Amendments to the Drawings

Attorney Docket No. 127976-1000

App. No.: 10/664,737
Reply to Office Action of 12/07/04
Annotated Sheet Showing Changes

FIGURE 11

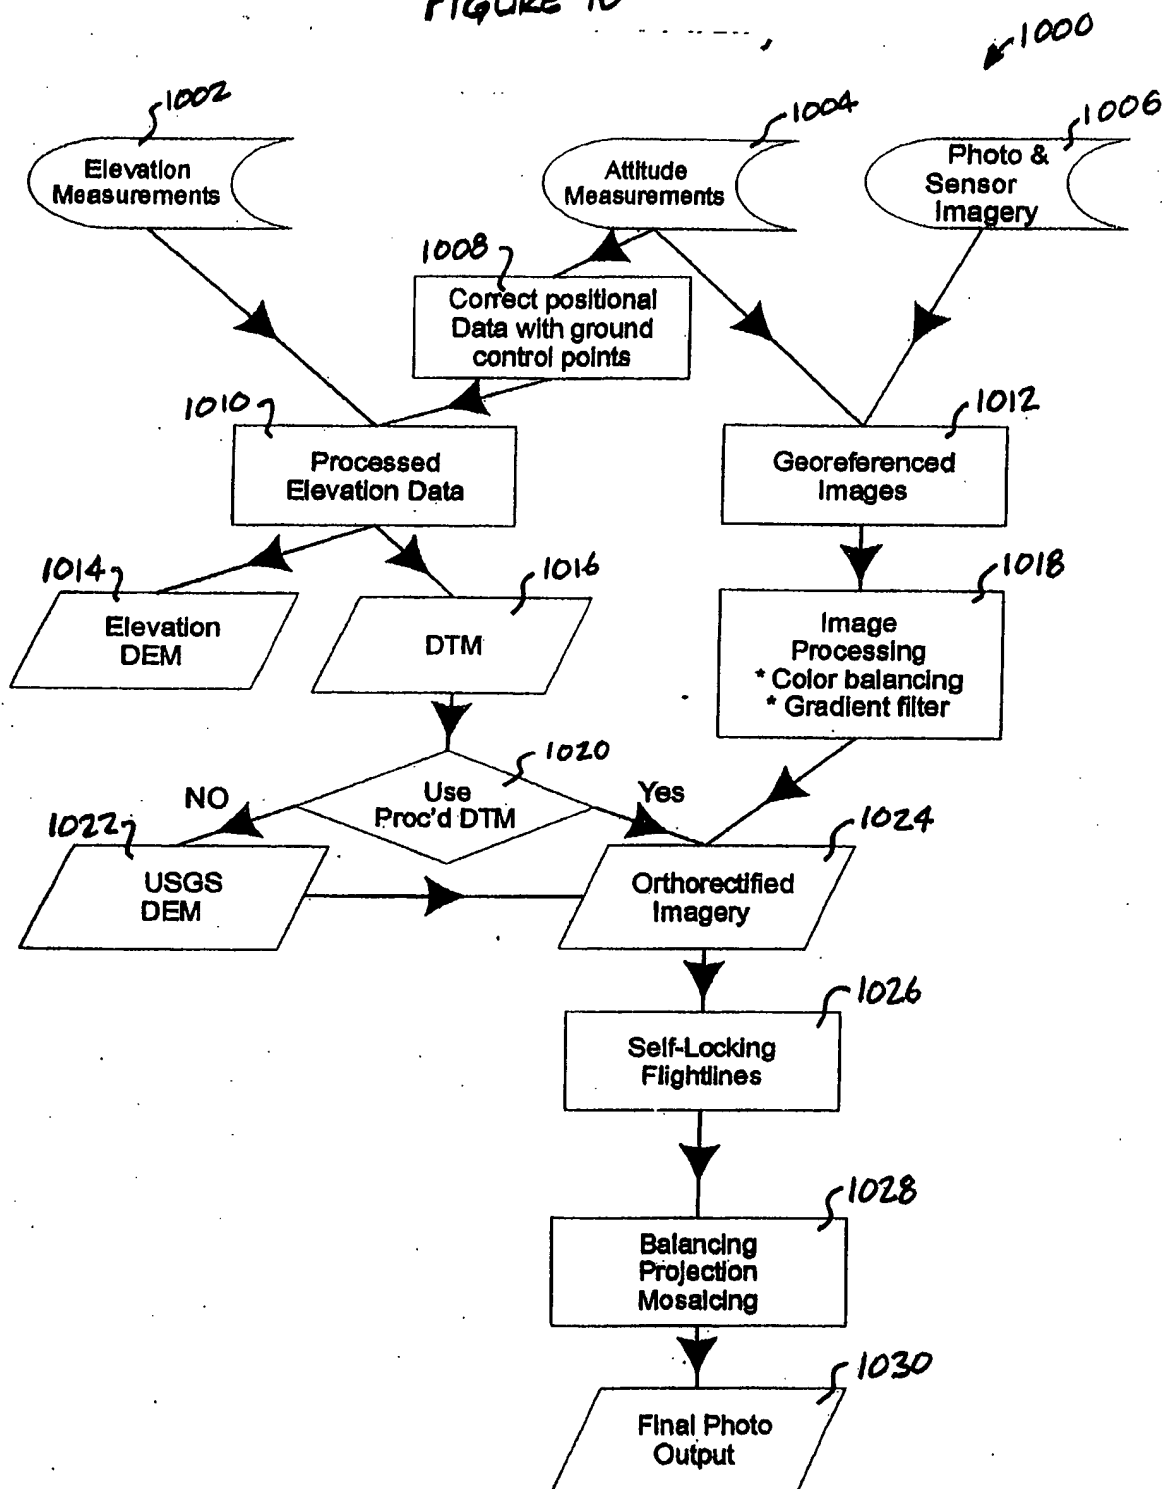
The sheet that includes Figures 11, 12, and 13 now replaces the original sheet that included Figures 11 and 12, and that portion of the sheet that included Figure 13. In Figures 11, 12, and 13 the lines identifying certain representational components have been repositioned for reasons of clarity. In Figures 11, 12, and 13, the boxes have been repositioned for reasons of clarity and stylistic preference. Additionally, Applicant has deleted some of the words in Figures 11, 12, and 13 without prejudice and for reasons of clarity. No new matter has been added to Figures 11, 12 and 13.

FIGURE 14

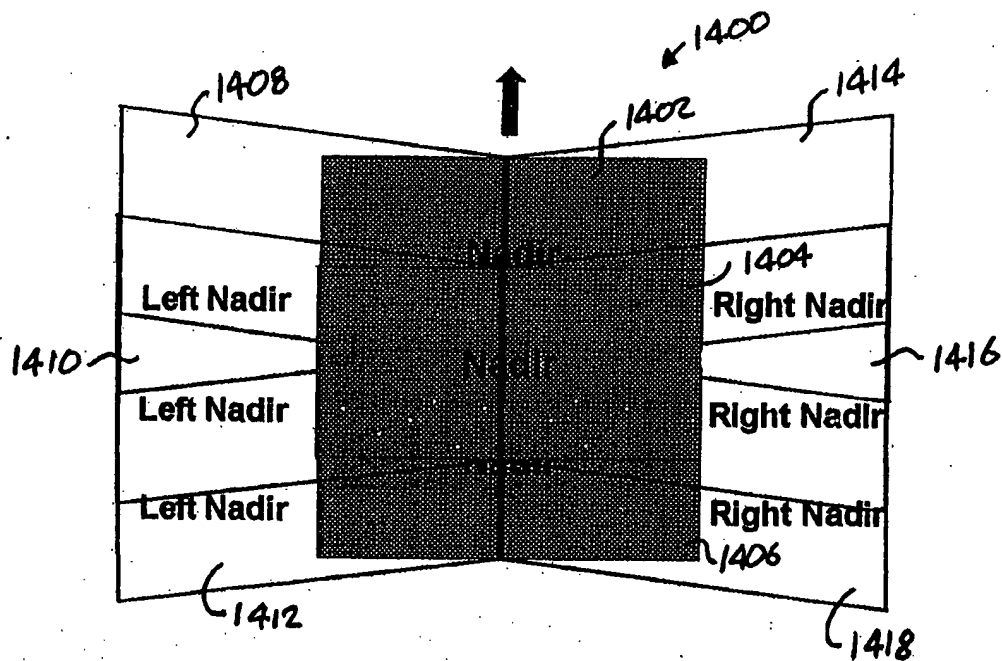
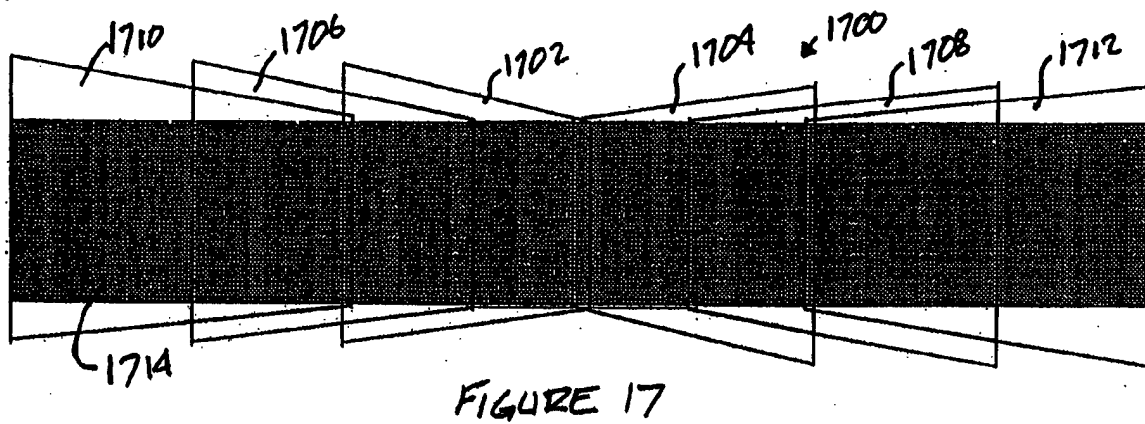
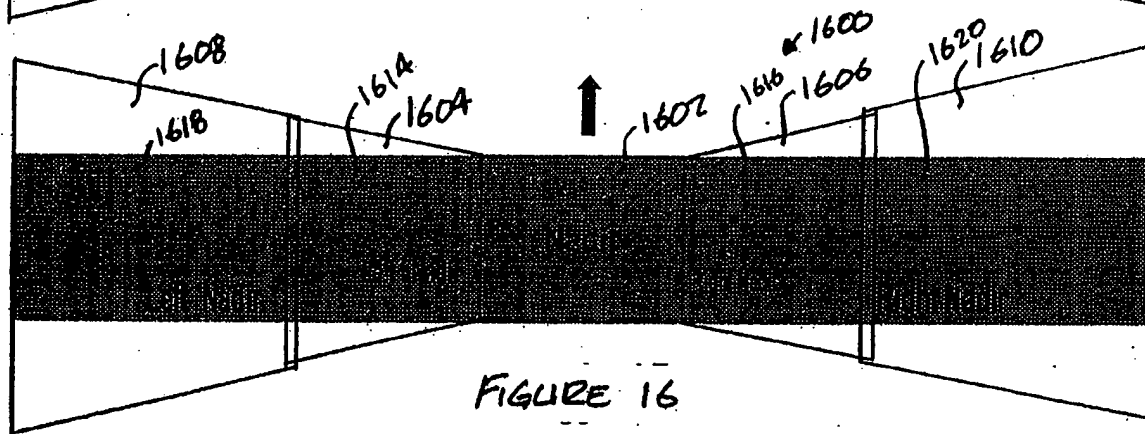
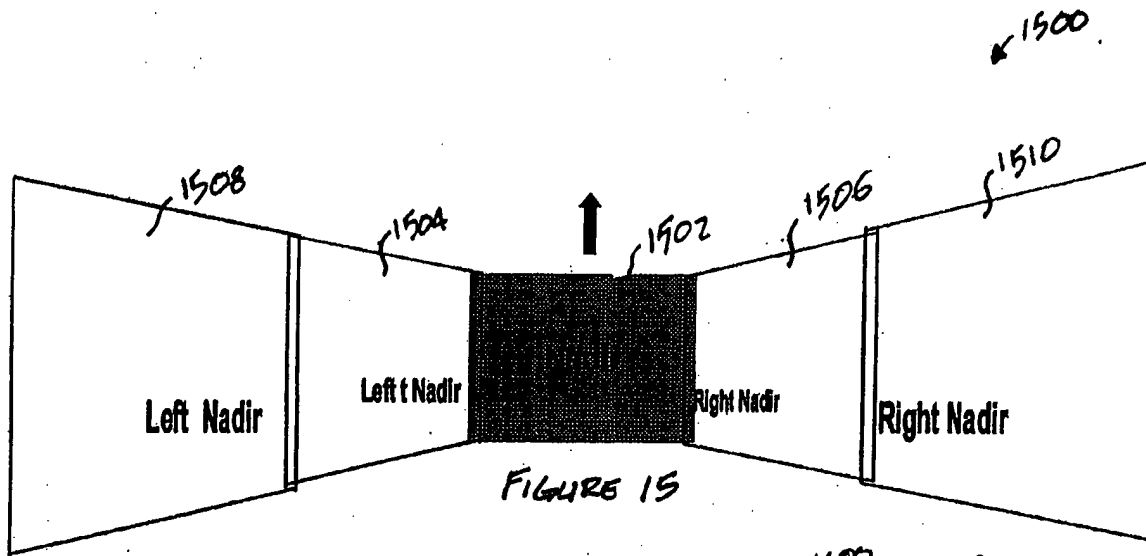
The sheet that includes Figures 14, and 15 now replaces the original sheet that included the portion of the sheet that included Figure 14 and the portion of the sheet that included Figure 15. In Figures 14 and 15 the lines identifying certain representational components have been repositioned for reasons of clarity. In Figures 14 and 15, the shape of the boxes have been changed and repositioned for reasons of clarity and stylistic preference. Additionally, Applicant has deleted some of the words in Figures 14 and 15 without prejudice and for reasons of clarity. No new matter has been added to Figures 14 and 15.

FIGURE 18

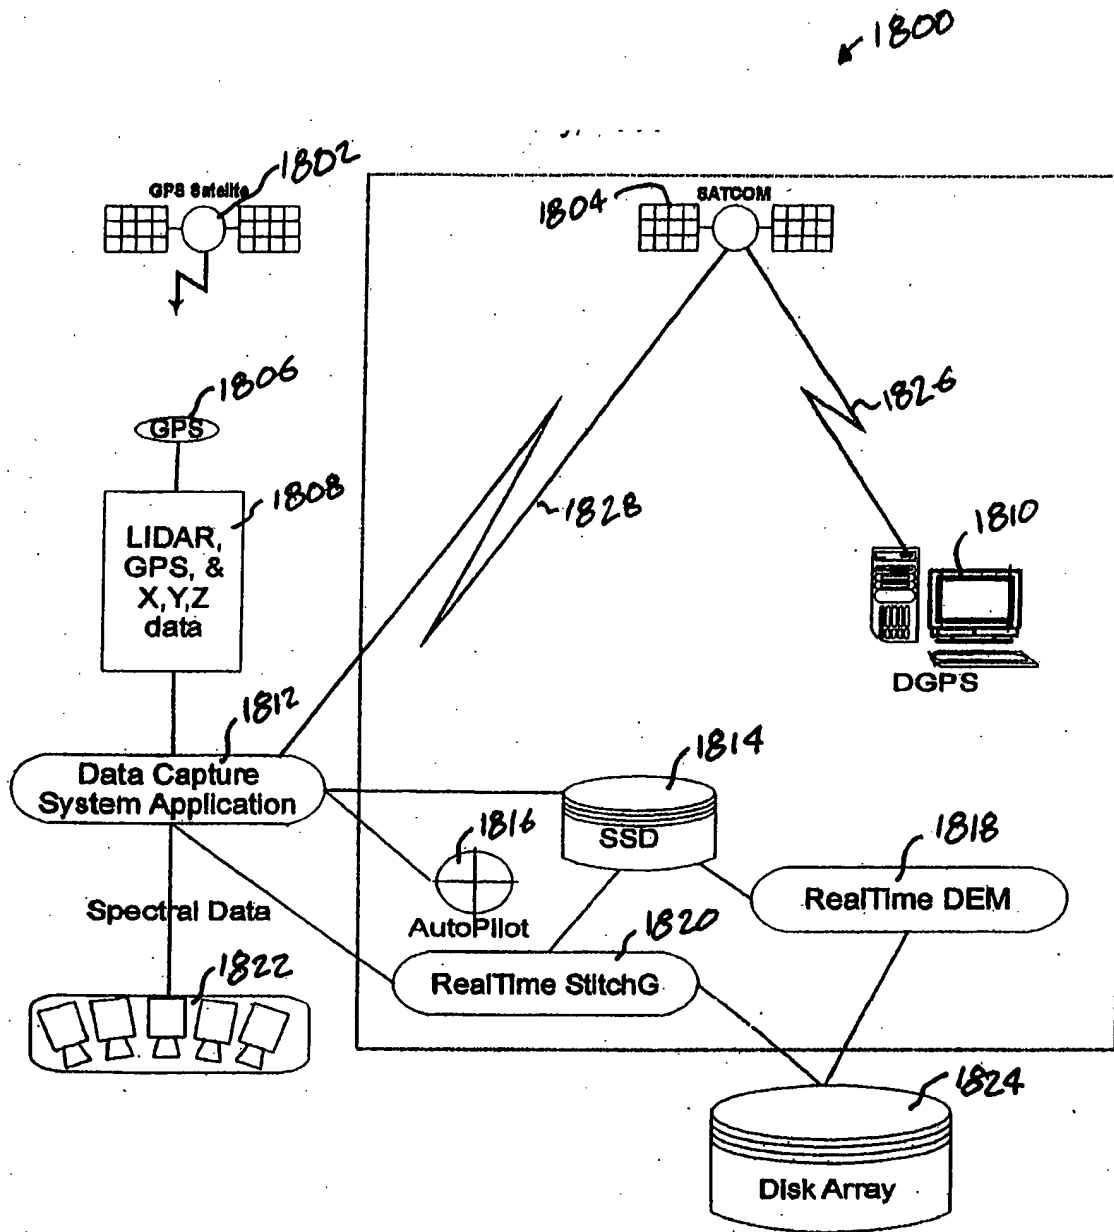
The sheet that includes Figure 18 now replaces the original sheet that included Figure 18. In Figure 18, the lines connecting and identifying certain representational components have been repositioned for reasons of clarity. In Figure 18, the shape of the boxes have been changed and repositioned for reasons of clarity and stylistic preference. Additionally, Applicant has deleted some of the words in Figure 18, without prejudice and for reasons of clarity. No new matter has been added to Figure 18.
